**CHATFIELD DAM & LAKE  
DENVER, COLORADO**

**ANTECEDENT FLOOD STUDY  
FINAL REPORT**

**TRI-LAKES REALLOCATION FEASIBILITY STUDY  
DECEMBER 2005**

### Independent Technical Review Comments and Responses

Figure 4 Location Map of NWS Precipitation Gages

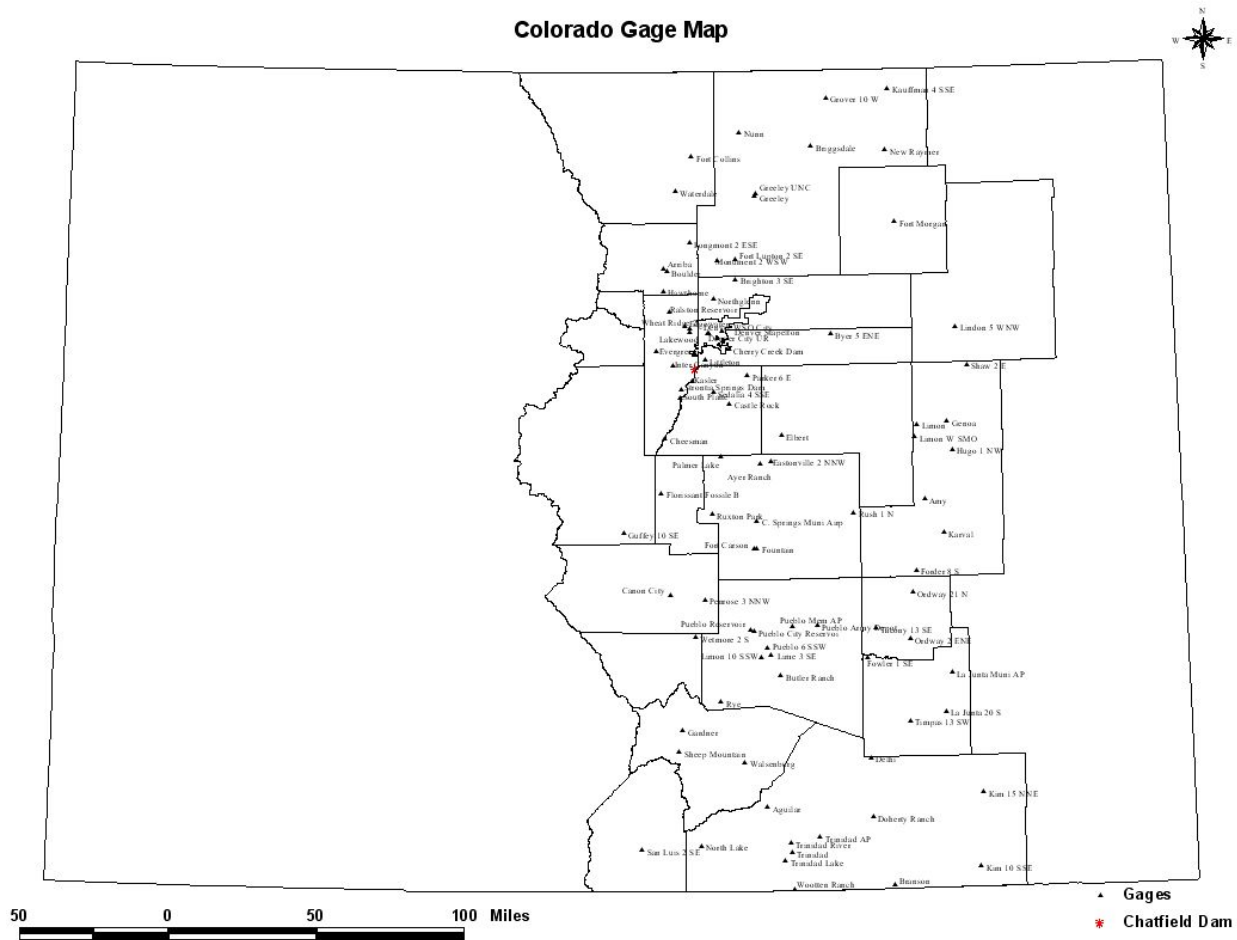
a. The 114 precipitation stations used in the basic analysis do not include gage data from many of the precipitation stations found along the Colorado Rockies located immediately east of the Continental Divide at elevations greater than Chatfield Dam. Some of these gages are located in the Chatfield Dam watershed. These stations should not only be analyzed in combination with your described data set but should be analyzed separately from those stations located on the plains (figure 4) to see if there is any significant difference in the antecedent to main storm precipitation ratio due to orographic/elevation effects.

RESPONSE: There are eleven additional NWS precipitation stations located in the watershed upstream from Chatfield Dam. Records from those stations were not included in the original analysis since they are located in the mountainous region. PMP amounts are greater in the foothills and plains areas of Colorado so the original analysis focused on precipitation stations in those areas. An analysis was made of the 10-day precipitation antecedent to the maximum 24-hour values recorded at the eleven stations located in the mountainous region above Chatfield. Results of this analysis indicate that the antecedent ratios would all plot well below the envelope curve shown on Figure 5. It should also be noted that the maximum 24-hour value recorded at the mountain precipitation stations was 2.85 inches at the Bailey station on May 7, 1969. Therefore, even if the ratios for these stations exceeded those from the plains stations, the envelope curve would not be impacted for large precipitation events in the magnitude of PMP.

**Figure 5 Antecedent Precipitation Ratios**

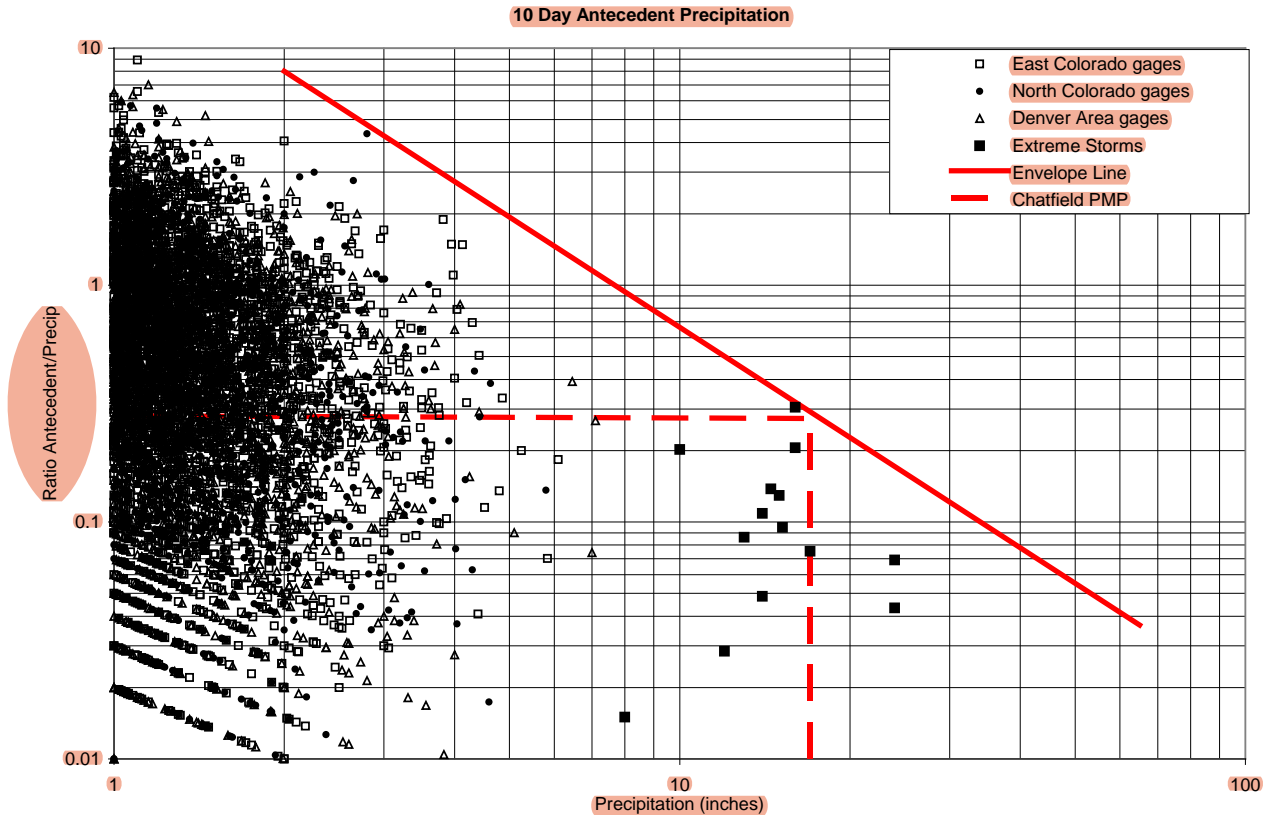
b. The relationship described on figure 5 is basically derived using point precipitation data. The drainage area above Chatfield Dam is 3018 square miles. Studies that involve drainage sizes larger than 100 square miles should evaluate the effect of large area storms. This is accomplished by studying clusters of precipitation stations, both antecedent and during the main precipitation event for storm area sizes similar to that of the drainage area size of interest. Major storms of record, as found in "Storm Rainfall of the United States," are useful to describe average precipitation depths for area sizes of interest in the main storm event. Typically, there is not an observed change in the ratio of the antecedent storm magnitude to the main storm for small area sizes (< 100 sq. mi.) but as storm area size increases the ratio usually increases somewhat.

e. In table 2 of the draft report, the June 17, 1965, Holly, Colorado precipitation is shown as 26 inches. We are not aware of a 24-hour precipitation amount of that magnitude occurring at that location on that date. McKee and Doesken (“Colorado Extreme Storm Precipitation Data Study”, May 1997) reported only 15.17 inches in 48-hours at Holly on that date.

f. In table 2 of the draft report, the ratio for the June 17, 1965, Falcon, Colorado storm is given as 0.306. This data does not appear to be plotted on figure 5. Doing so would raise the ratio value stated at the bottom of page 7 to near 30 percent and change the “Historic Envelope Antecedent Precipitation” value shown in table 3 to near 30 percent.

RESPONSE: Concur that a cluster analysis would likely result in the main event values being smaller than those from a single station value since more than 1 station values

**RESPONSE:** Concur with comment. Holly precipitation revised in table 2 and on Figure 5.

**RESPONSE:** Concur with comment; value plotted on Figure 5 was based on antecedent precipitation at the Ayers Ranch gage. This was later changed to Colorado Springs which was slightly higher. This has been revised and the envelope curve has been modified.

Figure 7 Chatfield Reservoir Pool Probability

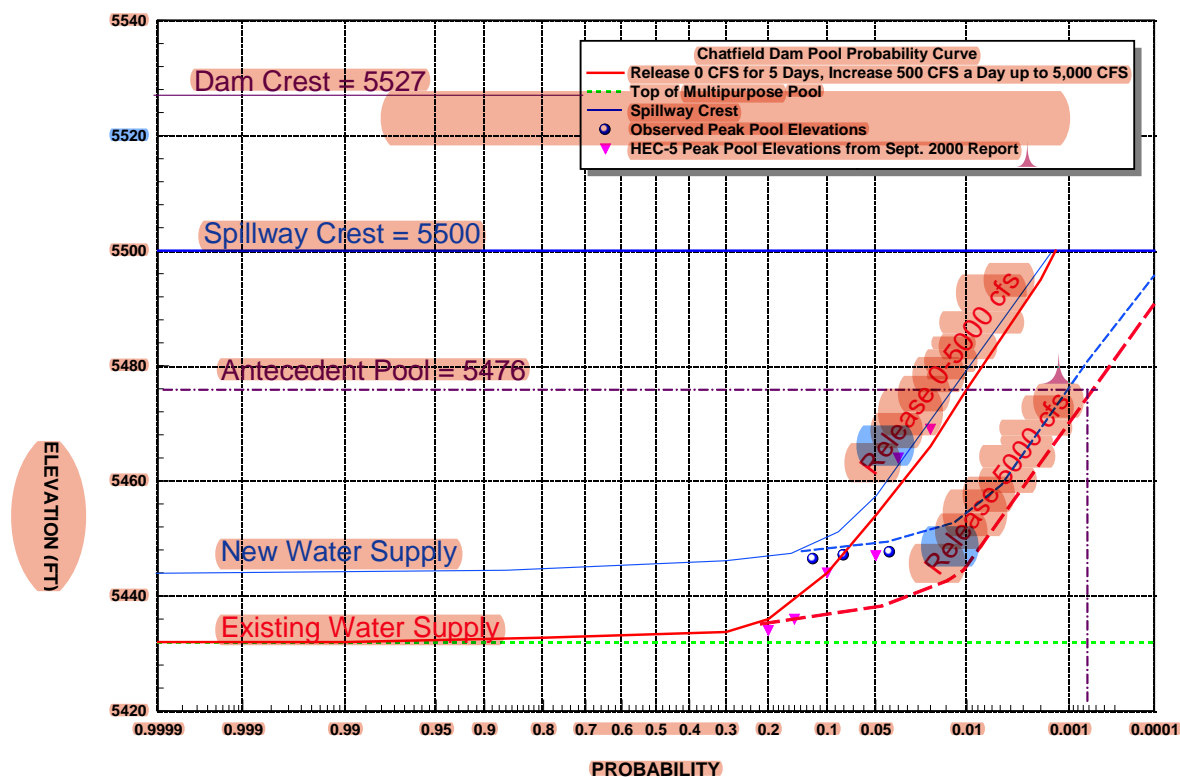
5. Page 13, first paragraph and Figure 7. The text indicates that the six highest pool elevations simulated with the HEC5 model of the Tri-Lakes system are shown on Figure 7. What operating rules were used to determine the highest pool elevations? It is not stated in the text, but I assume that the pool elevations were determined by using zero releases for five days, followed by increases of 500 cfs a day up to a maximum of 5000 cfs.

RESPONSE: The HEC5 model study utilized operating criteria from the Water Control Manual which included a target flow at Denver of 5,000 cfs and a maximum increase in release of 500 cfs per day. It also included balancing storage at Bear Creek and Cherry Creek reservoirs. Therefore, the operating criteria in the HEC5 model would generally follow the zero to 5,000 cfs release schedule used for developing the pool probability relationships. These values were used for comparison to validate the pool probability relationship based on simulation of historical flows.

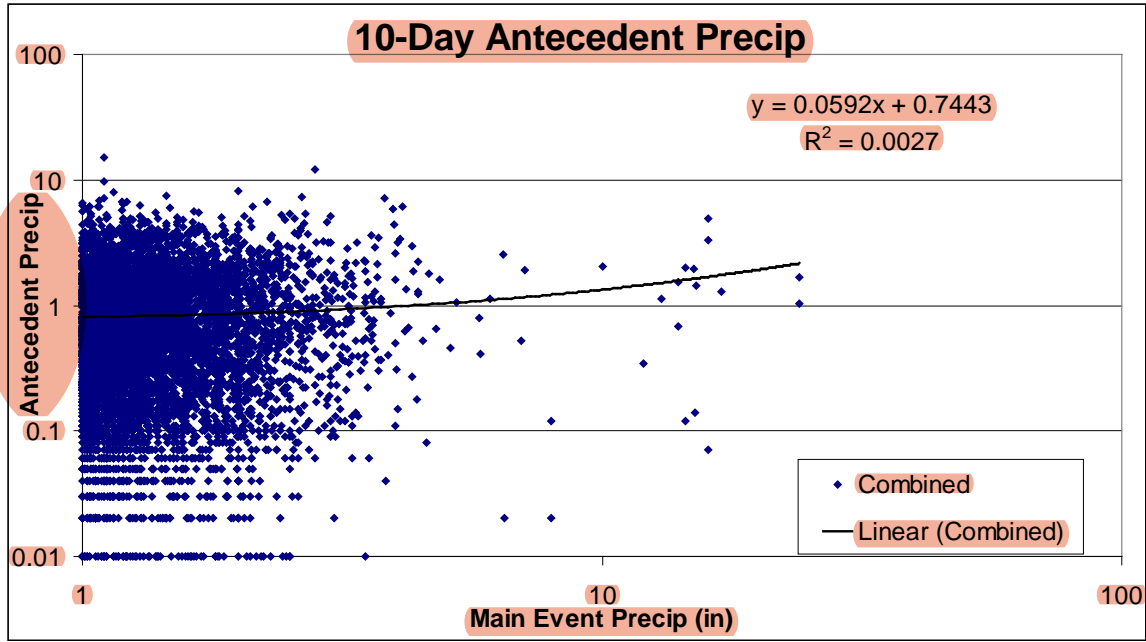
Technical Paper No. 49 (TP49) “Two- to 10- Day Precipitation for Return Periods of 2 to 100 Years in the Contiguous United States” provides the opportunity to quickly examine precipitation ratios formed between durations of intense precipitation (main event) and remaining precipitation (antecedent) derived from a precipitation frequency analysis. In this case, one can quickly find the average 4-day, 100-year precipitation and a similar value for a 10-day, 100-year amount for the Chatfield drainage. For example, in the Chatfield drainage (eye-ball estimate) the 4-day, 100-year precipitation equals 4.9 inches, whereas the 10-day, 100-year precipitation equals 5.9 inches. The difference between these values is 1.0 inch, resulting in a ratio of 0.20 (1.0/4.9). Using a 2-day, 100-year value (4.5 inches) with the 10-day, 100-year value

(5.9 inches) yields a ratio of 0.31 (1.4/4.5). Various other ratios can be formed through interpolation/extrapolation to test extremes using this information. Justifications/reasoning would have to be employed to evaluate results. Ideally, one would like to have such precipitation frequency analysis carried out to additional days and longer return periods similar to what is available for the Southwestern States and the Ohio River Region (NOAA Atlas 14). One needs to evaluate the limitations of forming ratios in this manner. Is the evaluation of 100-year precipitation applicable to events at the level of PMP? It is unlikely that the many main events (2- or 4-days) are part of the 10-day event. Also these ratios are from point precipitation (station) analysis and do not include storm area analysis [guidance on adjustments for spatial considerations could be applied from results from methodologies (1) and (3) noted in this review]. The reasonableness of the selected durations of main and antecedent storm lengths needs to be evaluated. The purpose of the draft study is not necessarily to derive an absolute value of the antecedent storm event but to provide enough evidence that the relationship between the antecedent precipitation event and the PMP would form a ratio of < 40 percent. If reasonable combinations cannot exceed a ratio greater than 40 percent, then the COE goal criteria have been satisfied.

**RESPONSE:** As suggested in this comment, an additional analysis was performed using 24-hour precipitation frequency obtained from NOAA Atlas 2 – Volume III Colorado and 10-day precipitation from Technical Paper No. 49. The largest point precipitation values in the vicinity of Chatfield Dam were used in this analysis. Precipitation values for 500-year frequency events were extrapolated using a normal-probability distribution. Ratios were computed by subtracting the 24-hour precipitation from the 10-Day precipitation and then dividing by the 24-hour precipitation. This represents a statistically based analysis with the 24-hour value as the main event and the difference between the 10-Day and 24-hour value as the antecedent precipitation. Results of this analysis indicated that the Ratio is always less than 40 percent throughout the entire range of frequencies as shown in the following table:

Frequency (years)	24-hr Precip (in)	10-Day Precip (in)	Ratio
2	2.0	2.7	.35
5	2.9	3.8	.31
10	3.3	4.4	.33
25	3.9	5.1	.31
50	4.2	5.5	.31
100	4.5	5.9	.31
500	5.4	6.9	.28
